CITY OF ALBUQUERQUE

**RE: 5720 La Anita Ave NW
Grading and Drainage Plan
Engineer's Stamp Date: 9/12/25
Hydrology File: J11D049
Case # HYDR-2025-00326**

ENGINEER'S SEAL	LOT 11 BLK 1 SANTA RITA ADDITION 2 5720 LA ANITA AVE.NW	DRAWN BY DEM
		DATE 9-11-25
	DAVID SOULE P.E. #14522	GRADING AND DRAINAGE PLAN
		SHEET # C1
	P.O. BOX 83924 ALBUQUERQUE, NM 87199 (505) 321-8099	JOB #

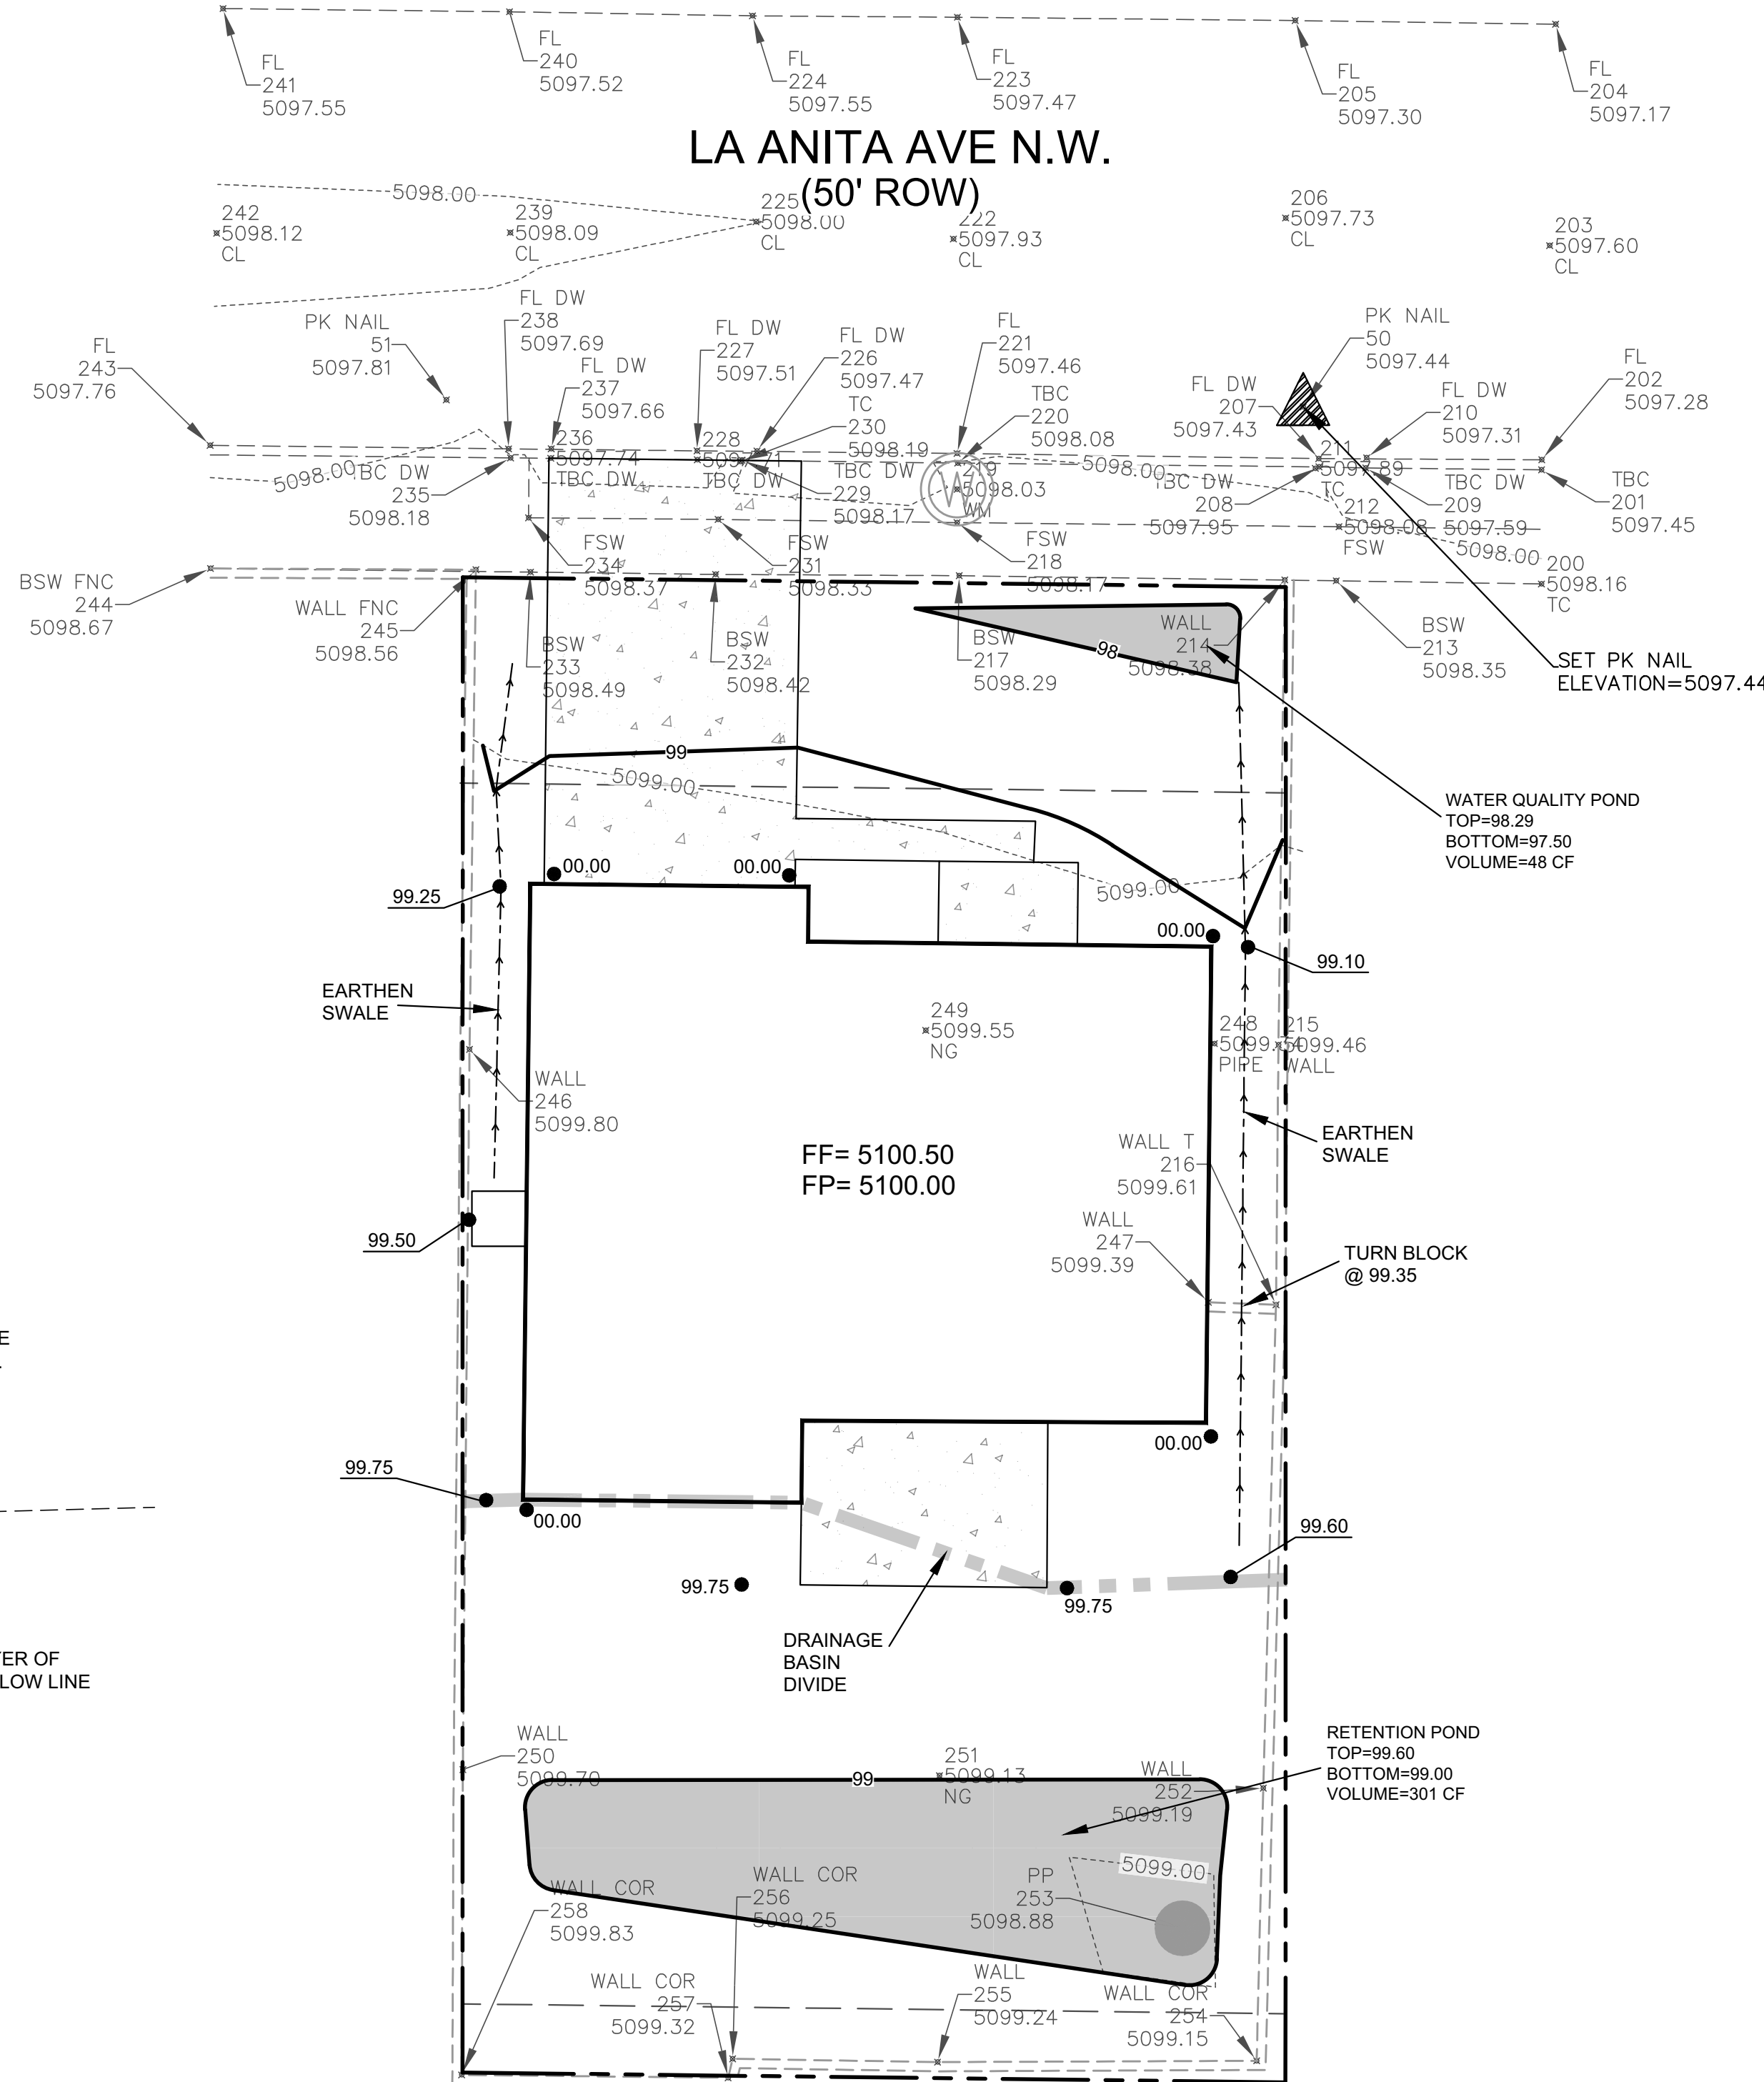
Based upon the information provided in your submittal received 9/12/2025, the Grading & Drainage Plans are approved for Building Permit. Please attach a copy of this approved plan in the construction sets for Building Permit processing along with a copy of this letter.

1. Engineer's Certification, per the DPM Part 6-14 (F): *Engineer's Certification Checklist For Non-Subdivision* is required.
